Stantec Consulting Services Inc. 482 Payne Road Scarborough Court, Scarborough ME 04074-8929

April 24, 2017

Subject: 1039 Riverside Street, Second Tee Business Park Unit 15 Final Site Plans Letter of Response #1

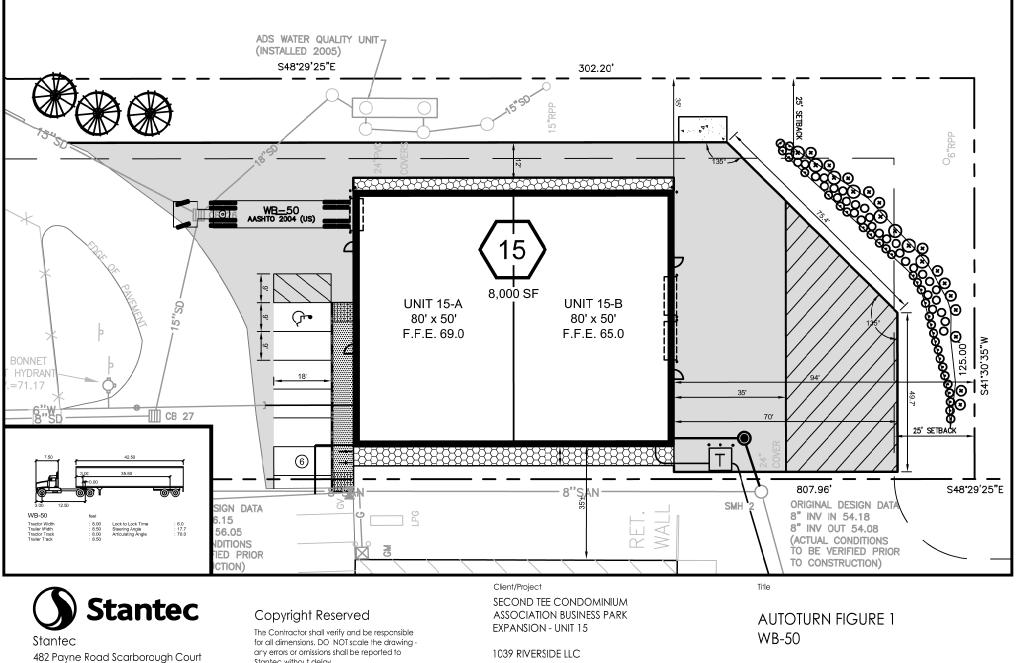
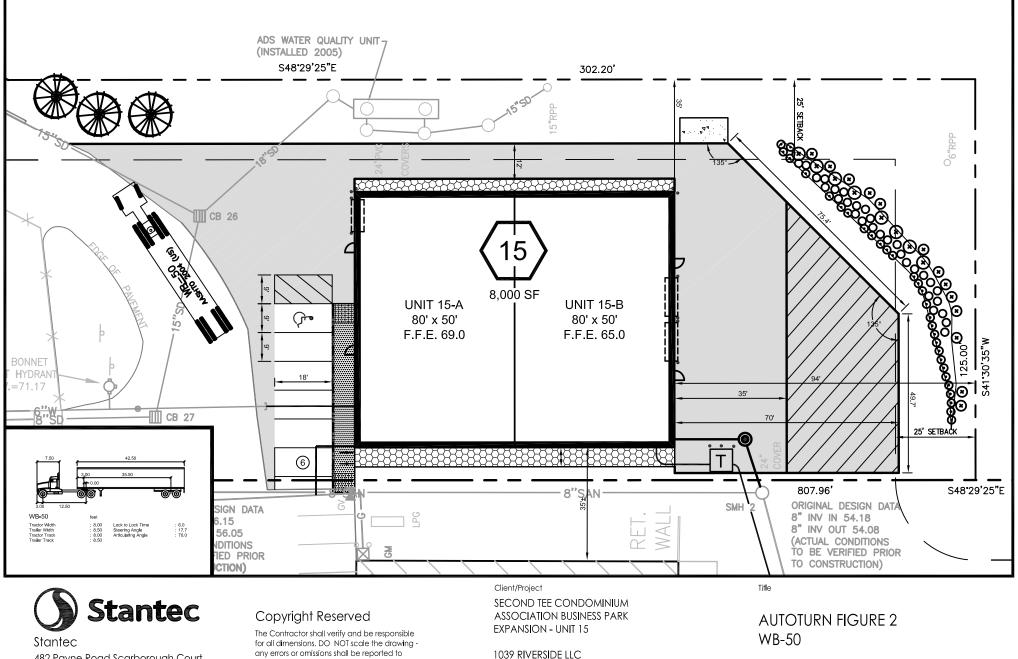
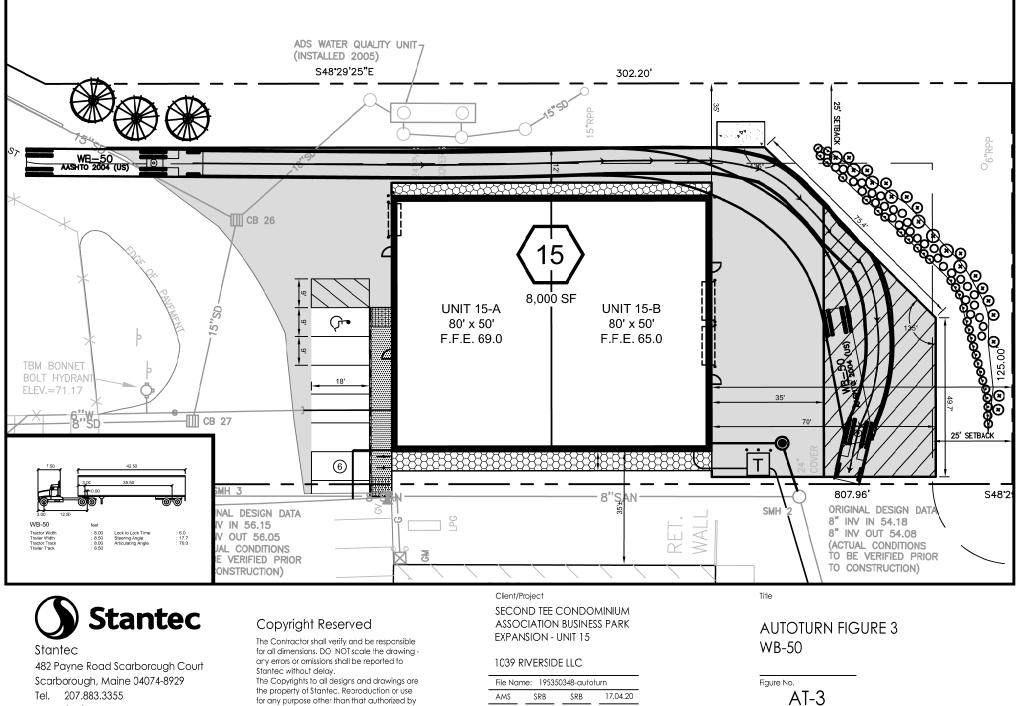
Loading diagram for each of the 2 units, showing how tractor trailers will access the loading bays (pl include dimensions so we can be sure that a truck accessing 15A would not block the main access drive).

Turning movement diagrams have been prepared showing how a trailer truck can access the site and have access to the overhead doors and are contained in Attachment A to this letter. We note that the overhead doors are not at 4' loading docks, thus these doors are expected to be mostly used for at grade smaller vehicle access. The owner anticipates only the occasional need for a larger trailer truck (WB-50) to enter the site and loading/unloading would occur using a ramp, which is common within the business park. Visits by the larger vehicles are infrequent and when they are onsite, any temporary parking for the trucks is generally accommodated by the park tenants, with little issue.
